678.22 VEHICLE LOOP DETECTOR

TRAFFIC LOOP LAYOUT SHEET #3	PROJECT NAME: WALLINGFORD - RUTLAND TOWN	PLOT DATE: 12-MAR-2007 11:30
	PROJECT NUMBER: AC NH 2207(1)S	DRAWN BY: C.A.K.
	FILE NAME: p99bl66.dgn	CHECKED BY: D.E.G.
	DESIGNED BY: D.W.E.	SHEET 42 OF 95

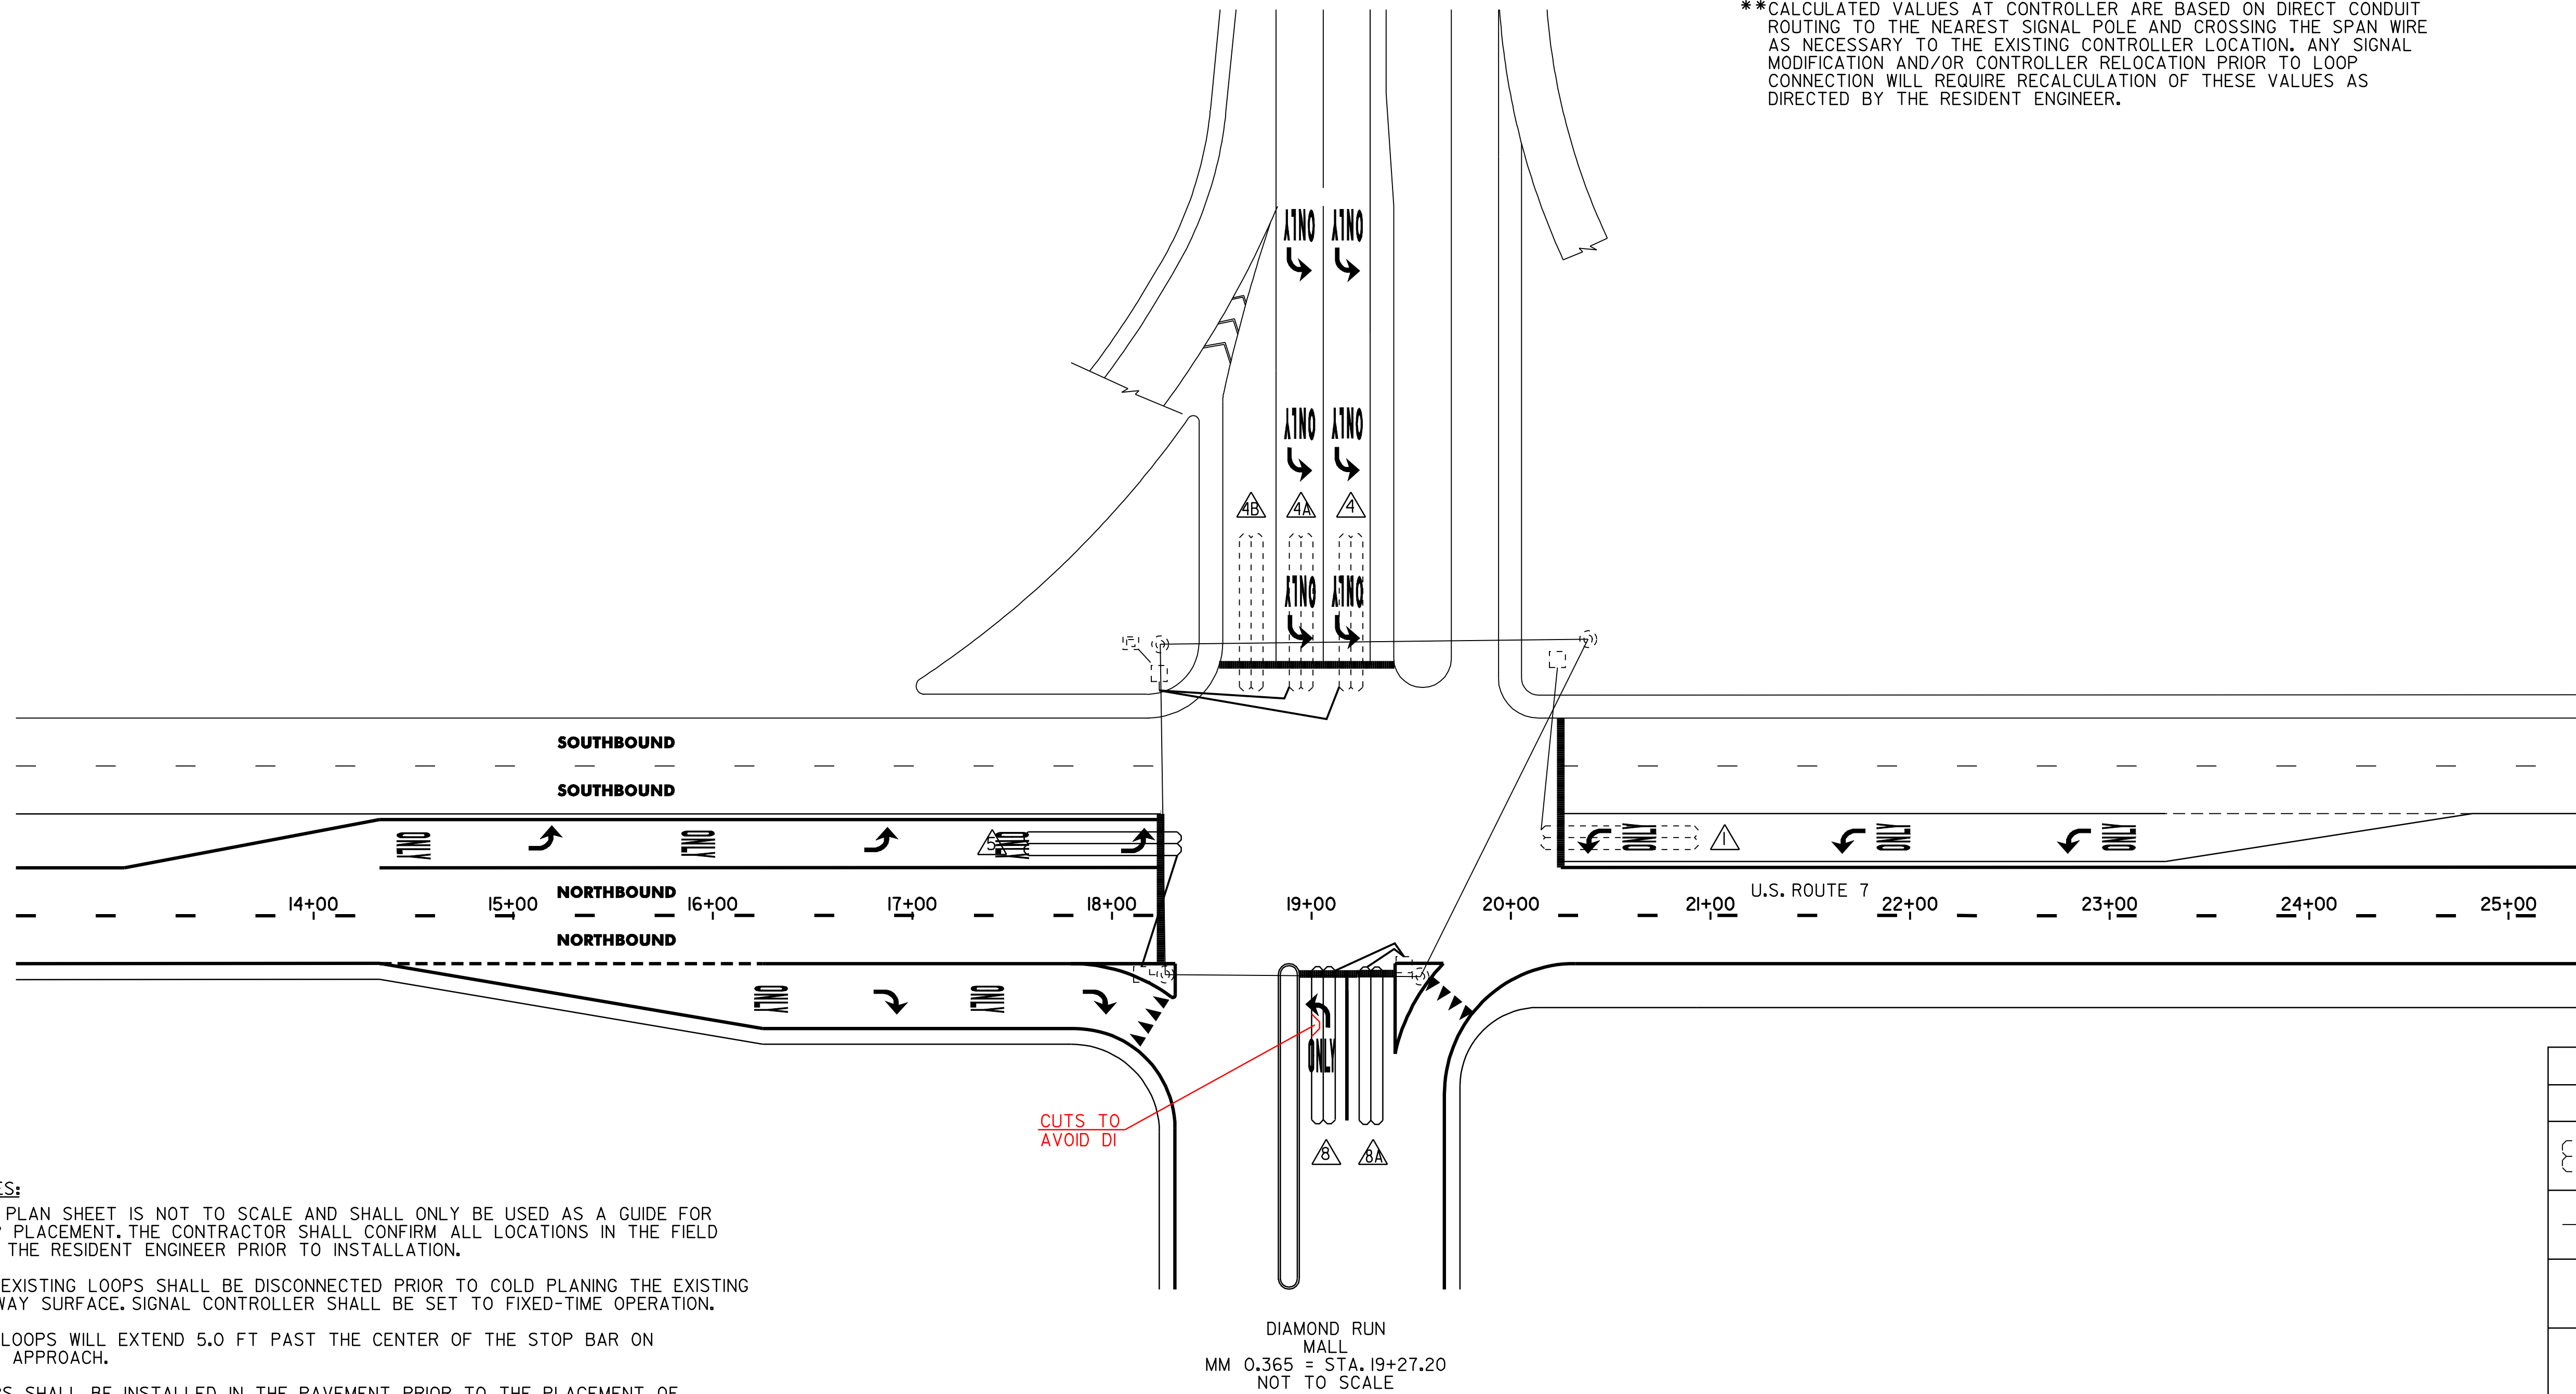
LOOP 5 - ~~160 FT~~ 162.5 FT
 LOOP 8 - ~~150 FT~~ 157.5 FT
 LOOP 8A - ~~137 FT~~ 135.5 FT
